Access Compliance Report Public Rights-of-Way (Curb Ramps)

Main Street: GRANJA_CT Cross Street: ARRIATE_ST Location: S

ADA ID: RPRK211119135855 Ramp Type: Type 4 - Parallel Initial Pass/Fail: Fail Overall Compliance: No Severity Score: 15

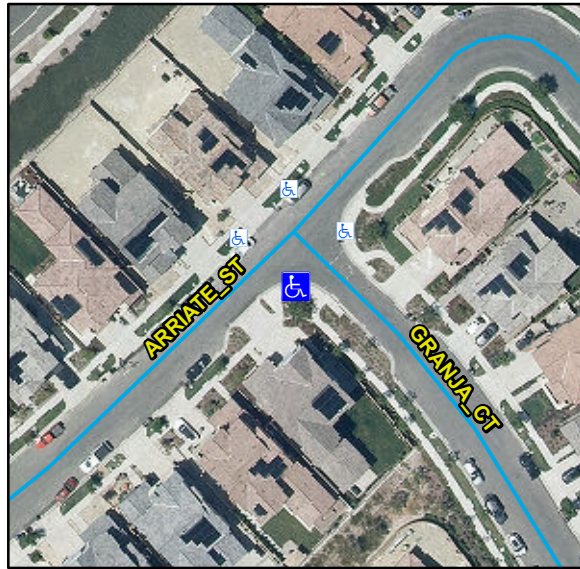
Compliance	Description	Data	Compliance	Description	Data
N/A	Ramp Length LT (in)	99	N/A	Ramp Length RT (in)	59
Yes	Ramp Width LT (in)	62	Yes	Ramp Width RT (in)	60
No	Ramp Run Slope LT (%)	9.1	Yes	Ramp Run Slope RT (%)	6.1
Yes	Ramp Cross Slope LT (%)	1.9	Yes	Ramp Cross Slope RT (%)	1.3
N/A	Landing Present	N/A	N/A	DWS Provided	N/A
N/A	Landing Length (in)	N/A	N/A	DWS Contrast	N/A
N/A	Landing Width (in)	N/A	N/A	DWS Length (in)	N/A
N/A	Landing Run Slope (%)	N/A	N/A	DWS Full Width	N/A
N/A	Landing Cross Slope (%)	N/A		DWS Offset Type	N/A
N/A	Landing Movement Obstructed?	N/A	N/A	DWS Offset Left (in)	N/A
	Landing Movement Type	N/A	N/A	DWS Offset Right (in)	N/A
N/A	Landing Shared	N/A			
N/A	Clear Space	Yes			
N/A	Clear Space To Crosswalk (in)	N/A			
N/A	Marked Crosswalk 1	No	N/A	Marked Crosswalk 2	Yes
	Crossing 1 Direction	NE		Crossing 2 Direction	NW
	Marked Crosswalk 1 Width (in)	N/A		Marked Crosswalk 2 Width (in)	144

Remove & Replace Curb Ramp With Two New Directional Ramps or Equivalent.

R304.3.2, STD 1115
